Subject: Review of Draft Interstate Access Request for I-75 at I-24 - Phase 2 in
Hamilton County.

SUBJECT: Interstate Access Request
Interstate 75 Interchange at Interstate 24 – Phase 2
Hamilton County, PIN 114174.01

INTERSTATE ACCESS REQUEST

INTERSTATE 75 INTERCHANGE AT INTERSTATE 24

FIGURE 4 -
PROPOSED MODIFIED
PHASE II IMPROVEMENTS

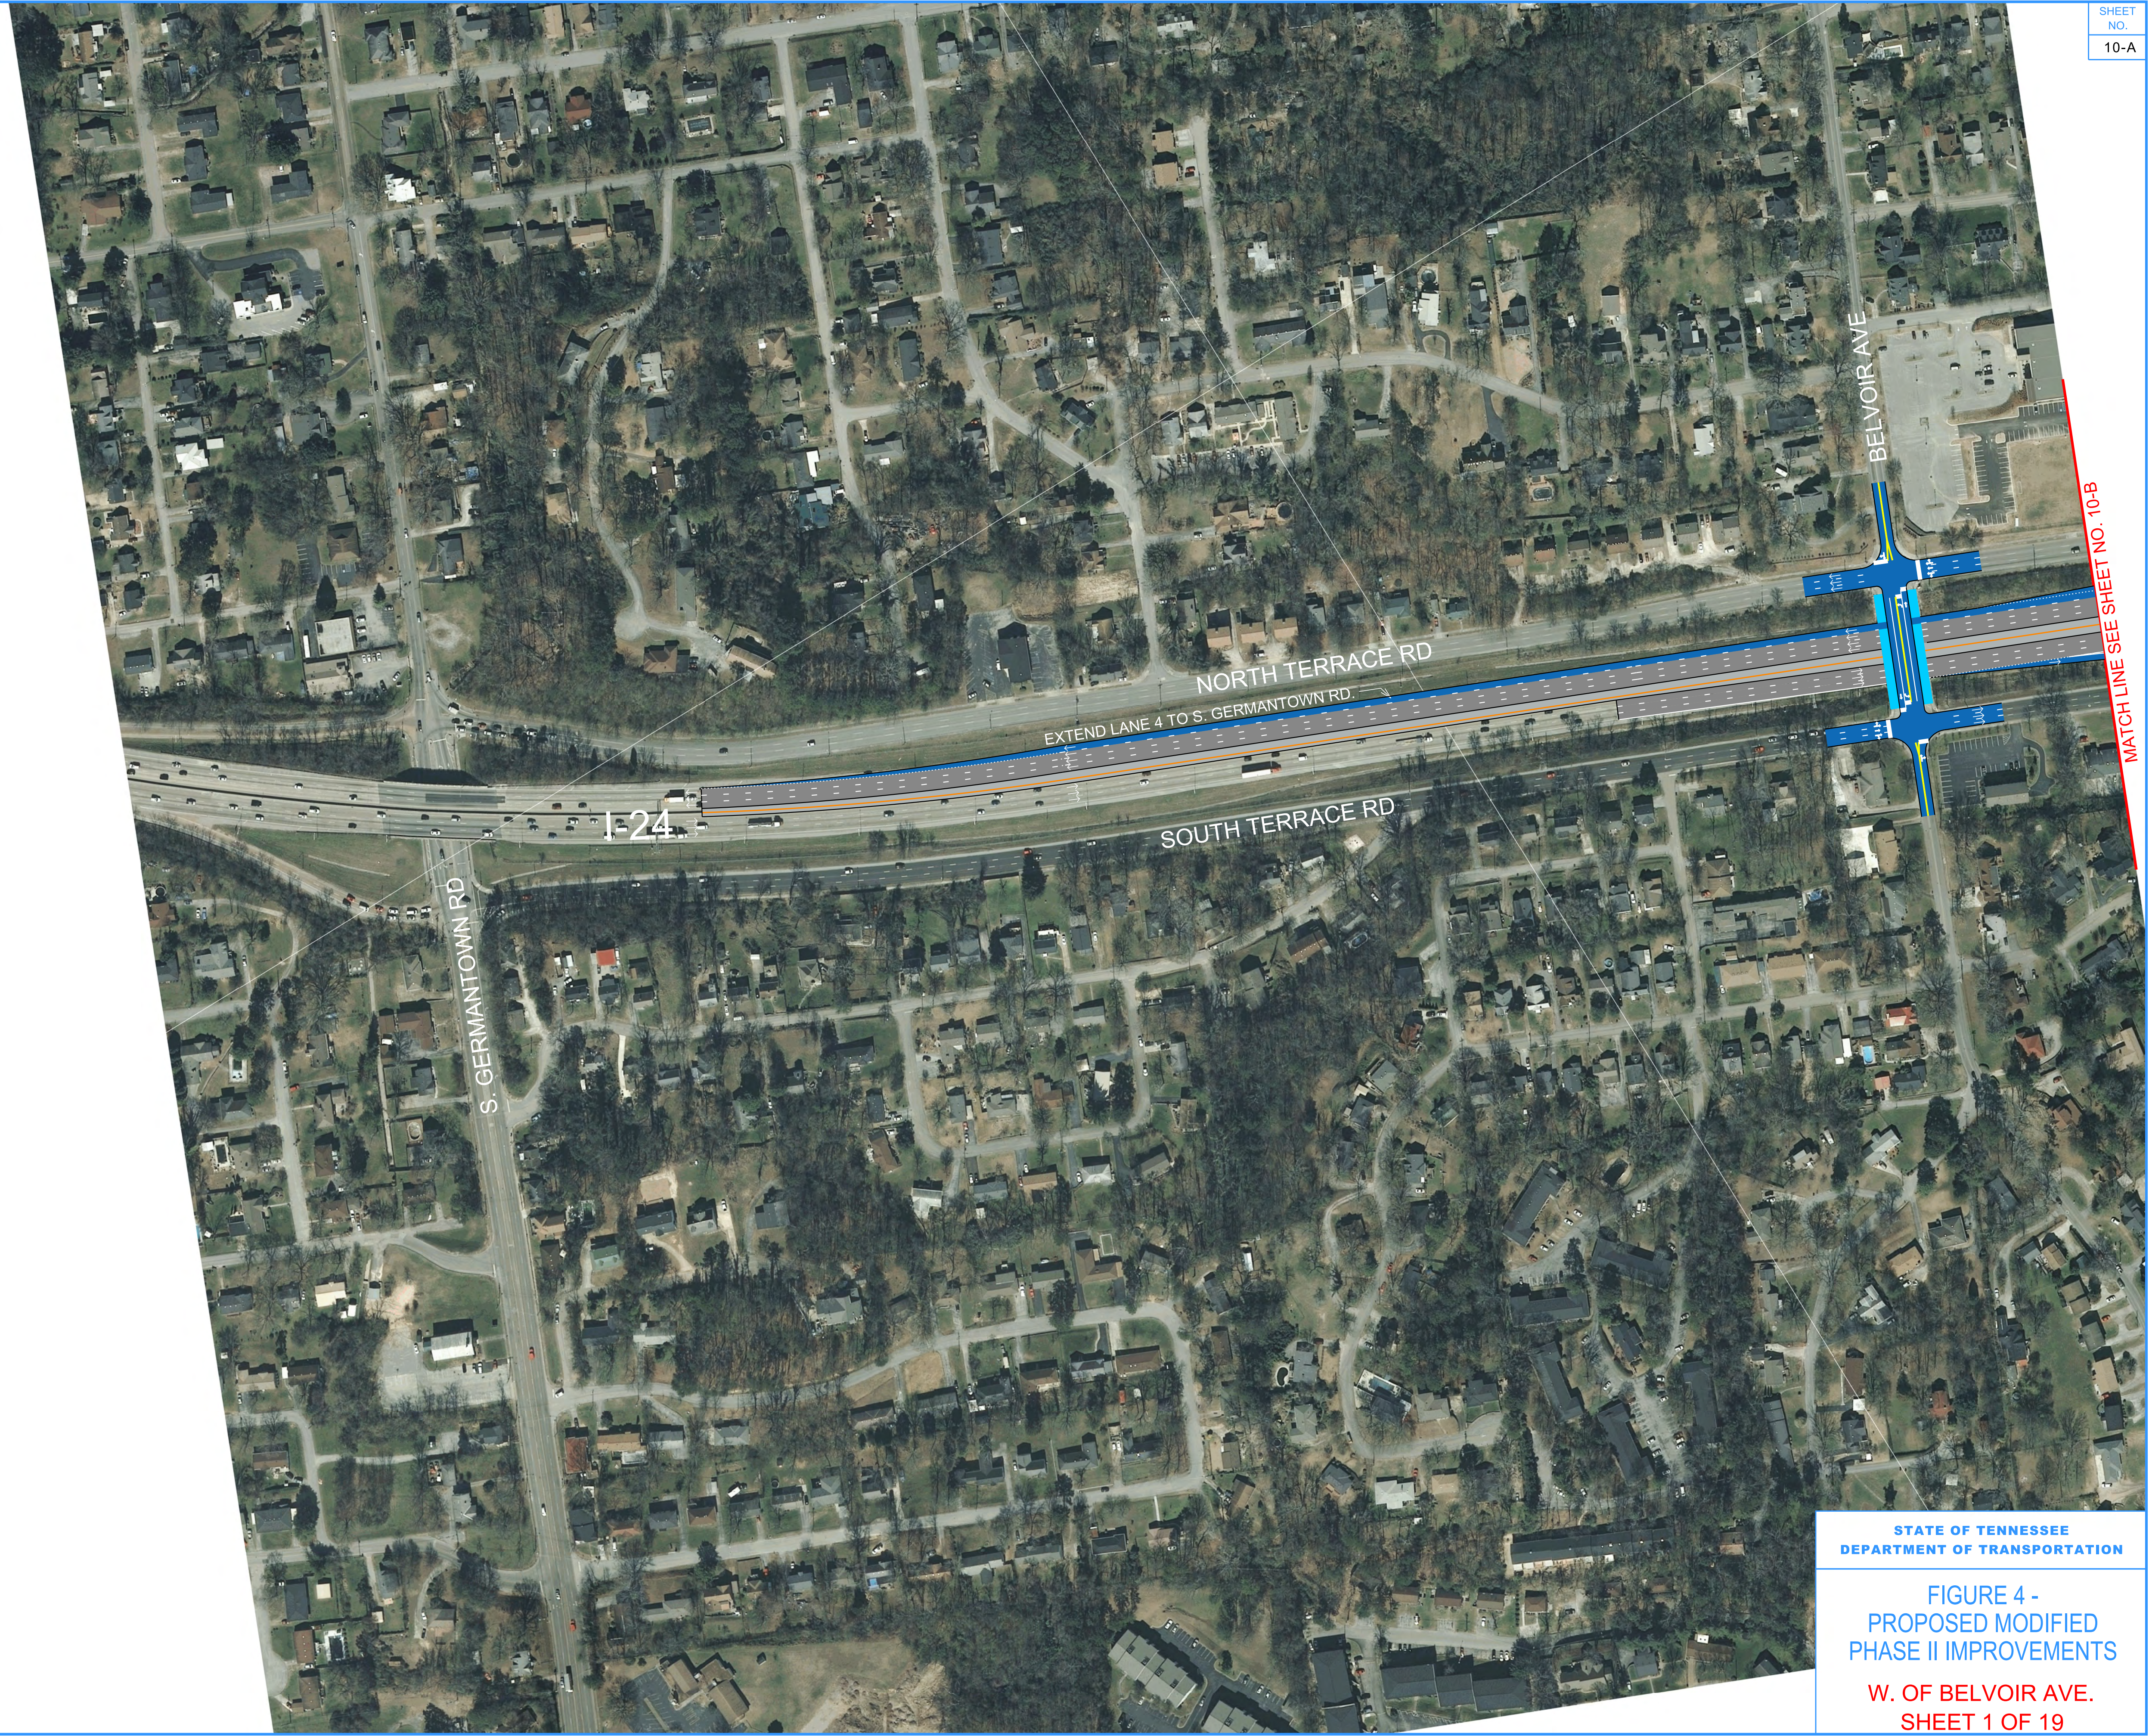
- I-24 WB at South Moore Road - two-lane off-ramp. The Original IAR maintains the current one lane off-ramp while the Modified Phase 2 provides a two-lane off-ramp with I-24 westbound lane 4 being an option lane.

- I-24 WB between South Moore Road and Belvoir Ave – modification of ramp sequence. The Original IAR is an On-Ramp/Off-Ramp sequence, while the Modified Phase 2 flips the ramps to an Off-Ramp/On-Ramp sequence, resulting in removal of a short weaving section on I-24 (approx. 1,300ft).

- I-24 WB – Extend the widened four-lane section further west. The Original IAR transitions I-24 westbound to three lanes east of Belvoir Ave, while the Modified Phase 2 extends the fourth lane, with the transition to three lanes beginning prior to the S. Germantown Road overpass.

- I-24 EB between Belvoir Avenue and South Moore Road - modification of ramp sequence. The Original IAR provides for an on-ramp/off-ramp sequence, while the Modified Phase 2 reverses the ramps' order to an off-ramp/on-ramp sequence. The proposed modification eliminates the approximate 800-foot weaving that currently exists and would remain under the approved Original IAR.

Figure 4 shows the I-24 proposed Modified Phase 2 improvements.

FIGURE 5

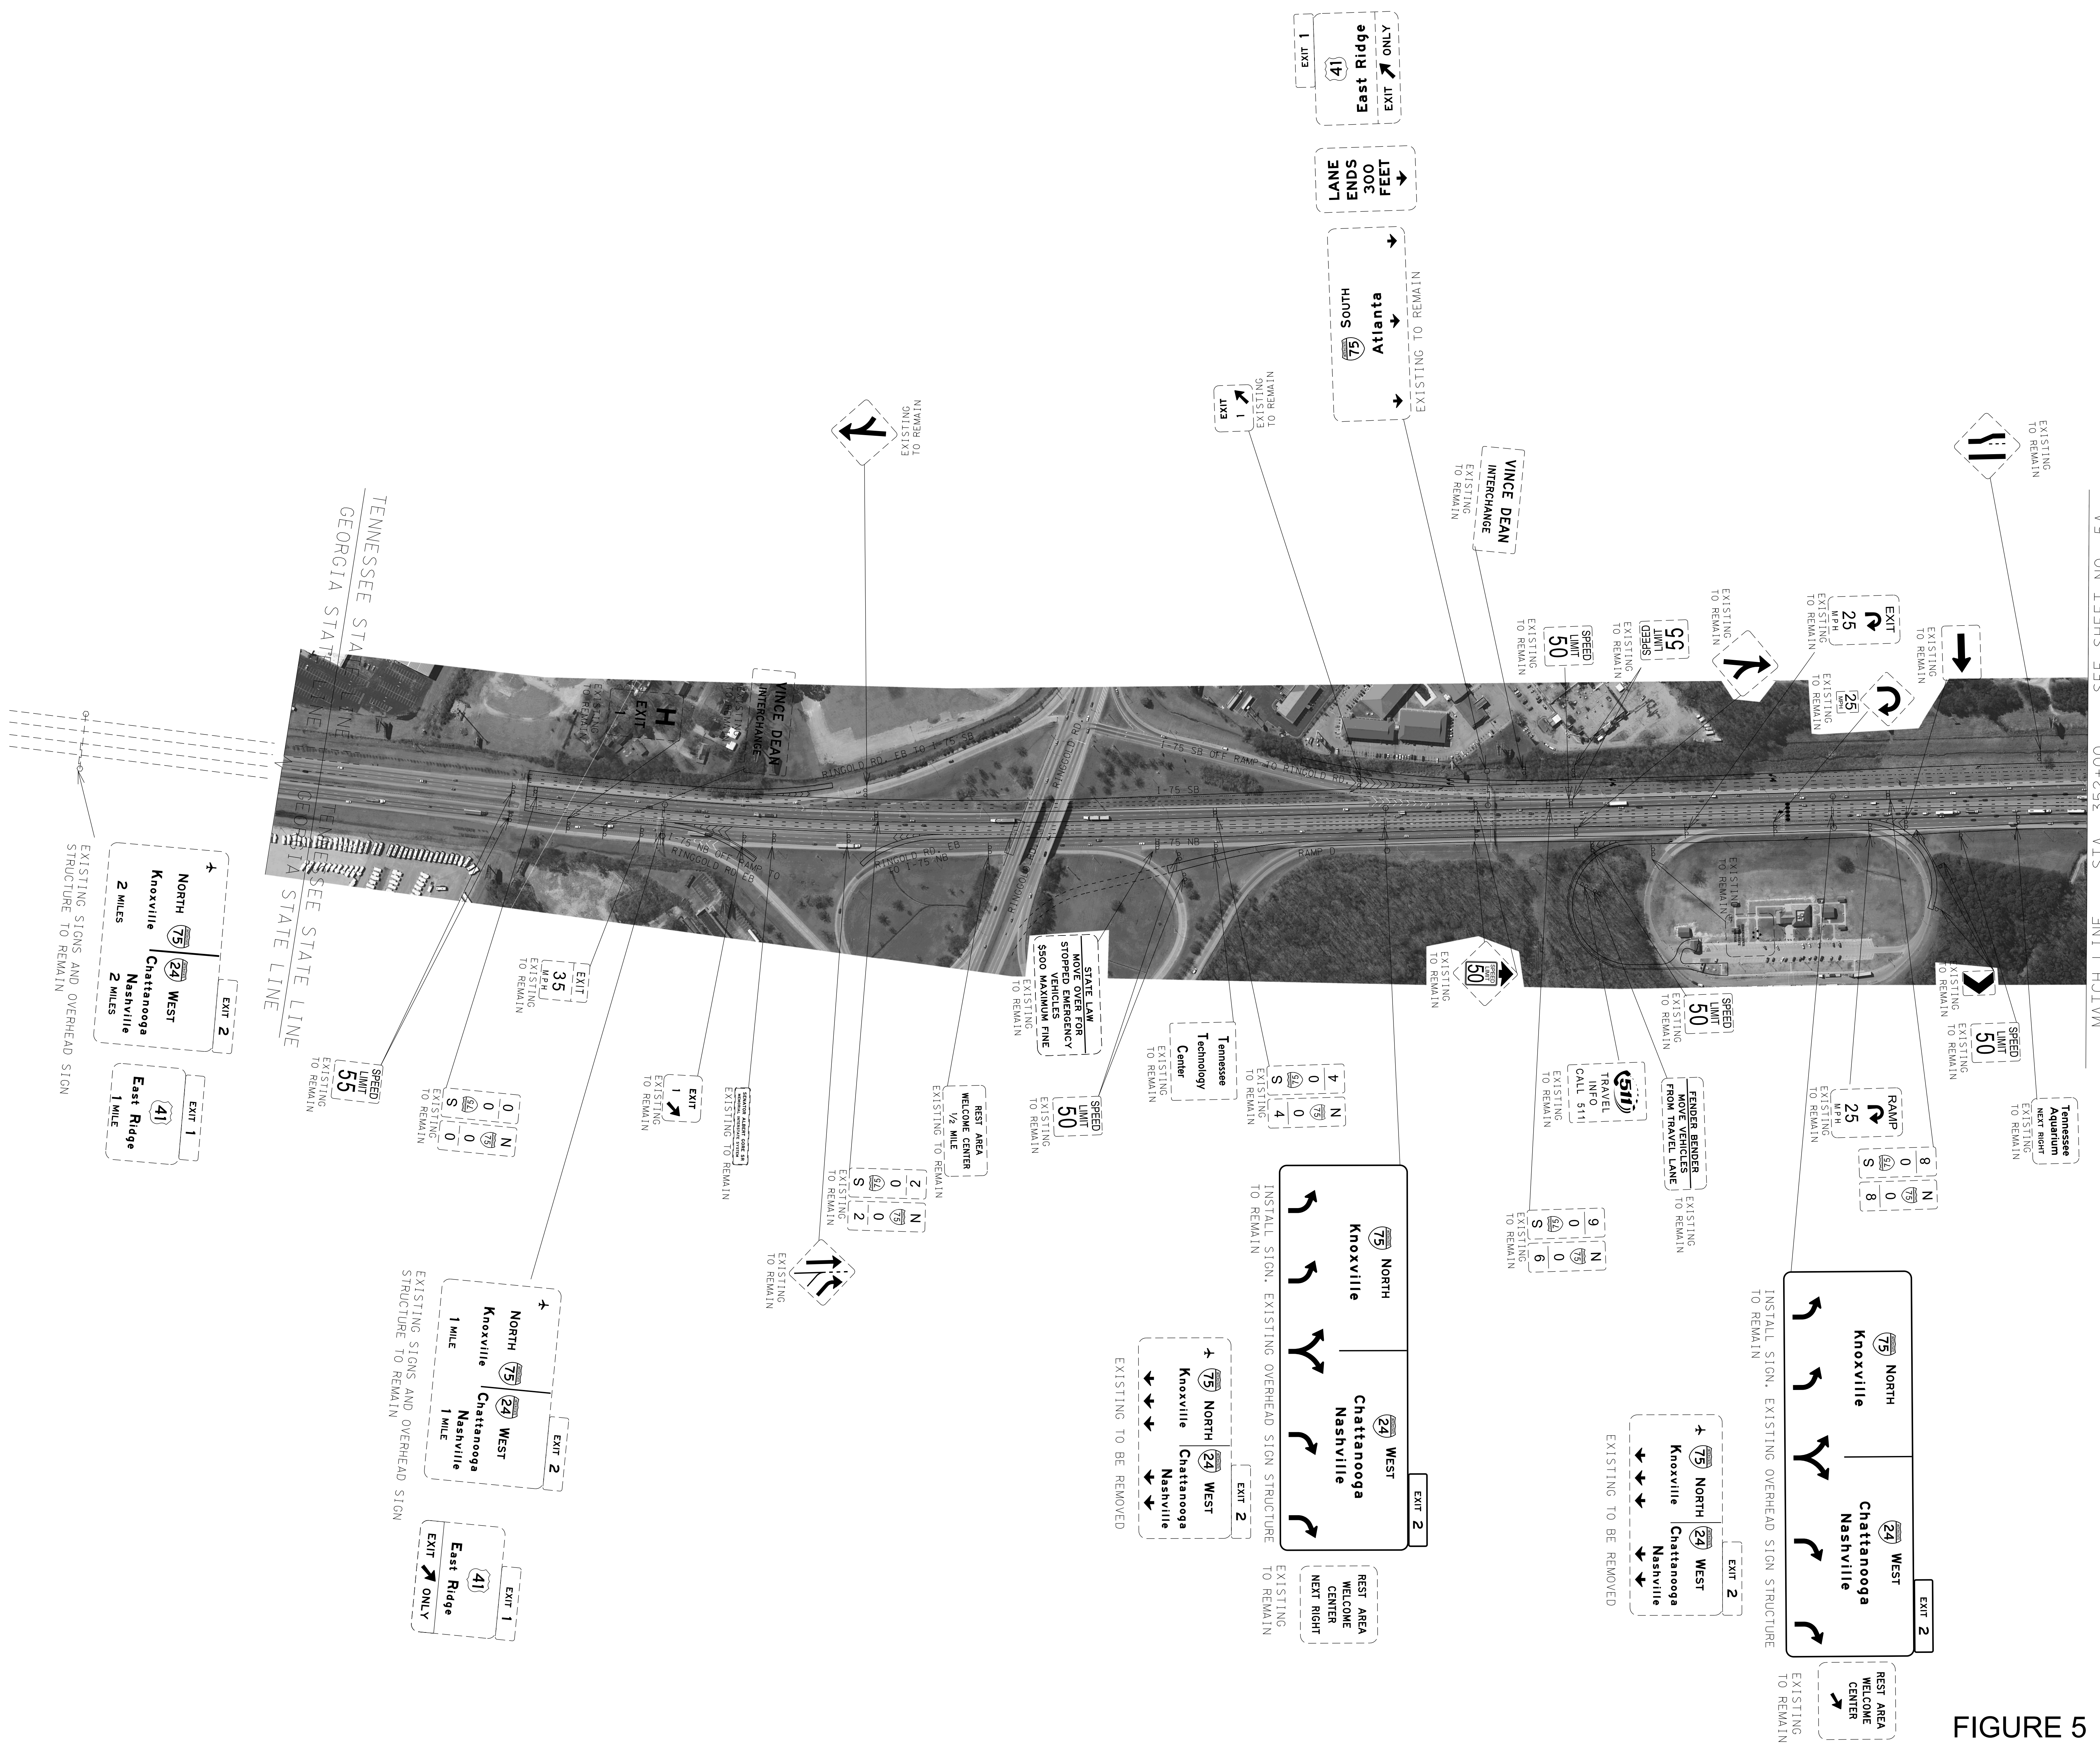
Figure 5 illustrates a conceptual layout for highway guide signing under proposed conditions.
